**RE: Del Webb @ Mirehaven Phase 2A  
Grading & Drainage Plan Revision 4  
Engineer's Stamp Date 3-11-16 (Rev. 4 Date: 08/17)  
Hydrology File: H09D017F**

Re: Revised Grading and Drainage Plan, Del Webb @ Mirehaven, Phase 2A – Design  
Revision #4 - Addendum #1 to Drainage Management Plan for Del Webb Phase 2 @  
Mirehaven Tracts M of the Watershed Subdivision - DRB Case No. 1006864 and  
Hydrology File: H09D017F.

## DEL WEBB @ MIREHAVEN PHASE 2 PROPOSED BASINS MAP

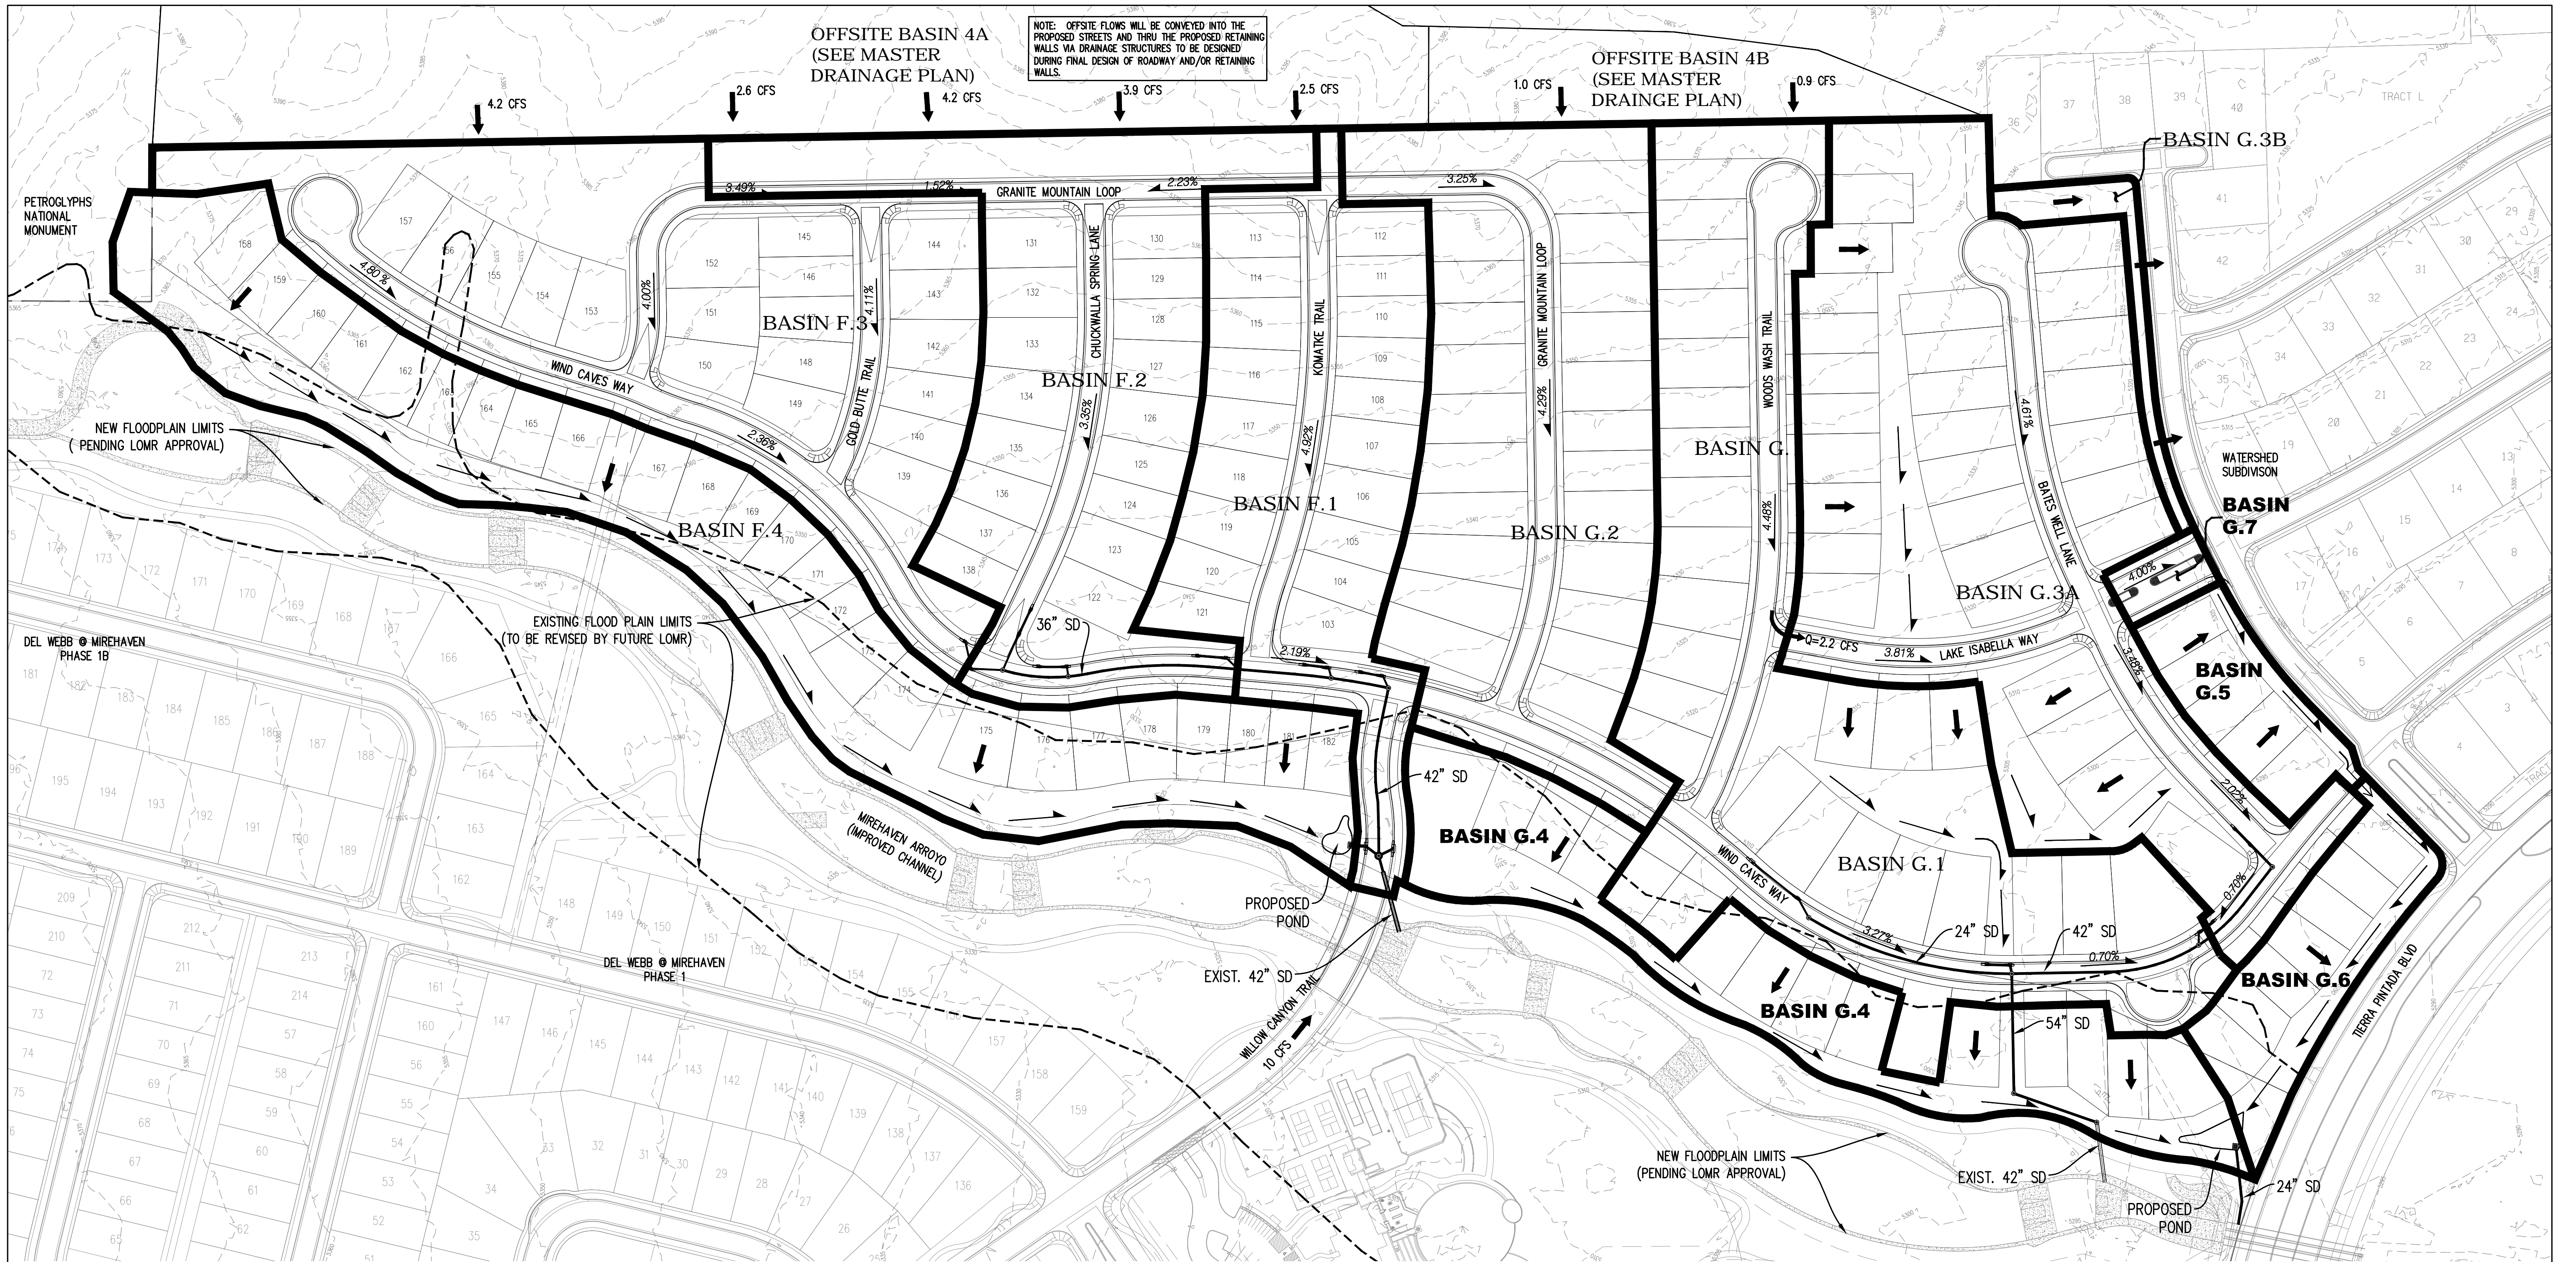
1. An Engineer Certified Addendum to the Drainage Report is required to support the new drainage pattern. The following should be addressed:
  - a. Proposed Basin Map: Basin G.5 will now drain into G.6
  - b. Geometry and hydraulic capacity of the new swale adjacent to lot 22.
  - c. Hydraulic capacity of the swale behind lots 16-22, accounting for the additional flow from G.5. This swale may need to be upsized.

In response to your letter dated August 21, 2017. Please find enclosed a revised Basin Map which shows Basin G.5 flow adjacent to Lot 22 and combining with Basin G.6. I have also provided update swale analysis to show the new swale adjacent to Lot 22, which is specified as a 5' wide, 1' deep swale of 1"-2" fractured cobble in Design Revision #4. In additions, I have also provided updated swale analysis for the swale behind lots 16-22, which the plan shows as a 7' wide, 1' deep swale of 1"-2" fractured cobble. In these swale analysis, it shows that the depth of flow based on the addition of Basin G.5 is still within the limits of the designed cross-sections mentioned above. There are no adverse affects with rerouting of Basin G.5 along Lot 22 with a new swale or having combining with Basin G.6 in the existing swale behind Lots 16-22.

5' wide channel 1' deep = side  
slopes 40% Q= 3.1cfs (Basin G.5)  
Q100=3.1 cfs < Qallowable=6.06cfs

7' wide channel 1' deep = side  
slopes 28% Q= 3.1cfs (Basin G.5)  
Q100=3.1 cfs < Qallowable=8.87cfs

7' wide channel 1' deep = side slopes 28%  
Q= 6.9cfs (Basin G.5 + 1/2 Basin G.6)  
Q100=6.9 cfs < Qallowable=10.49cfs

7' wide channel 1' deep = side slopes 28%  
Q= 10.7cfs (Basin G.5 + Basin G.6)  
Q100=10.7 cfs < Qallowable=12.91cfs
